RE: **PETITION NO. 1425** – Gaylord Mountain Solar Project 2019, LLC petition for a declaratory ruling, pursuant to Connecticut General Statutes §4-176 and §16-50k, for the proposed construction, maintenance and operation of a 1.9-megawatt AC solar photovoltaic electric generating facility located at 360 Gaylord Mountain Road in Hamden, Connecticut, and associated electrical interconnection.

STATE OF CONNECTICUT
CONNECTICUT SITING COUNCIL

Figure 3. Proposed Site Layout and Location of Wetlands

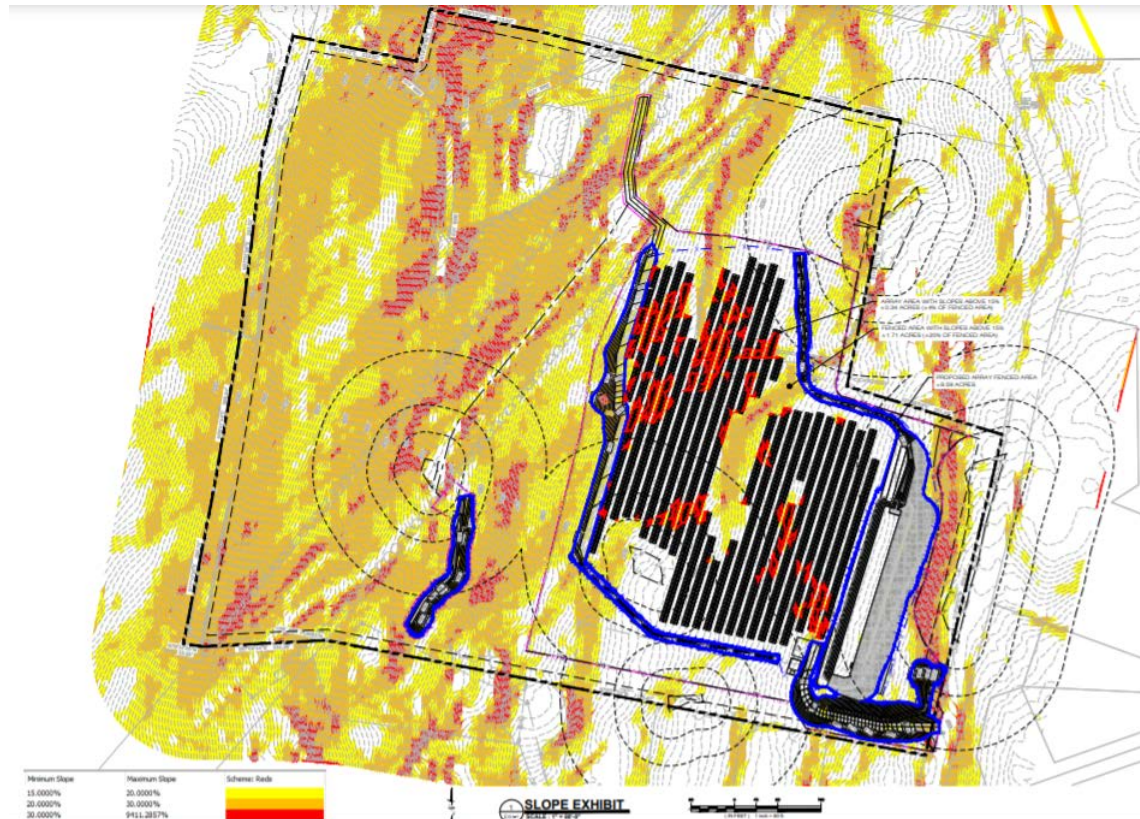
184. A total of five wetlands, collectively comprising approximately 0.44 acre, are identified within the site property. Wetlands 1 and 4 are scrub-shrub and emergent vegetated wetlands; Wetland 2 is transitional scrub/shrub, cleared/maintained emergent wetland that has been disturbed, Wetland 3 abuts Gaylord Mountain Road with varying degrees of historic impacts including vegetation management and accumulation of debris, and Wetland 5 is forested (refer to Figure 3). (GMS 1, Exhibit H, pp. 17-18; GMS 2, response 47)

Figure 4. Proposed site layout of panels on slopes greater than 15/20/30 percent

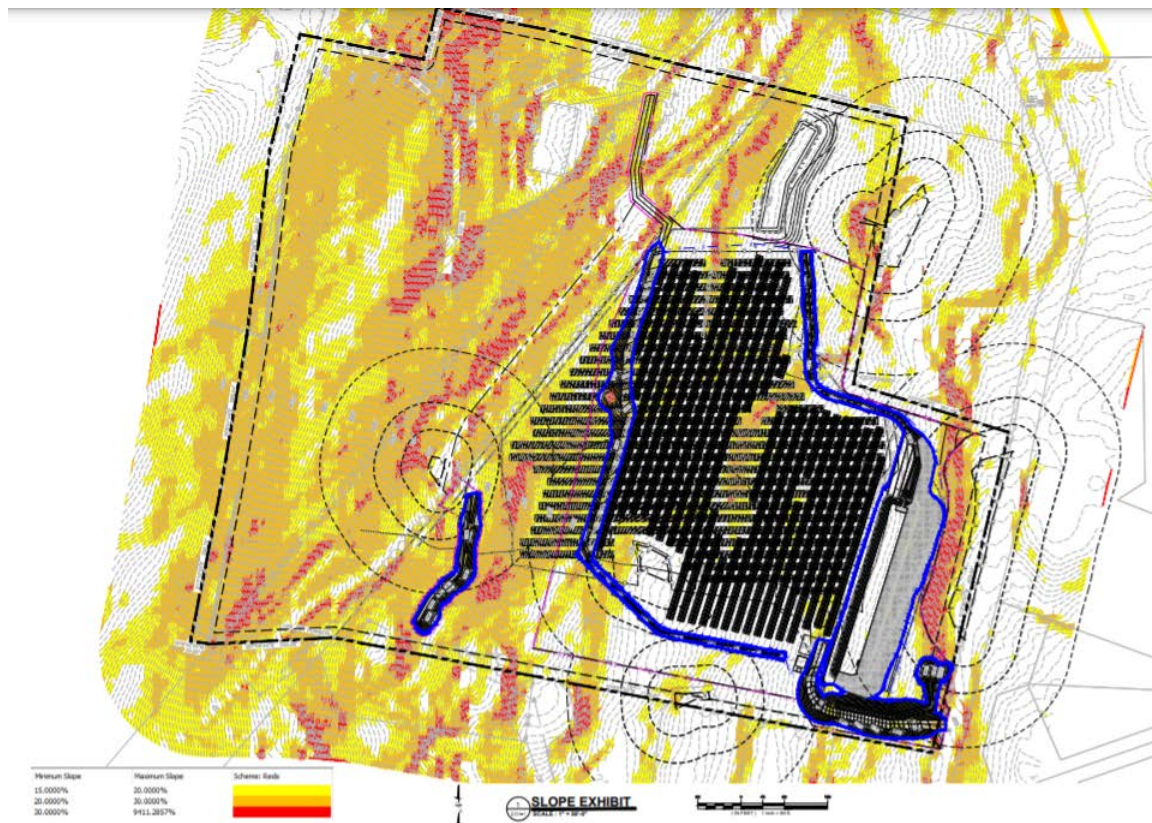
78. Approximately 1.71 acres (or 20 percent) of the 8.6 acre solar field area have slopes greater than 15 percent. Within the solar field, solar panels would be installed on approximately 0.34 acres (or 4 percent) with slopes greater than 15 percent (refer to Figure 4). (GMS 11)
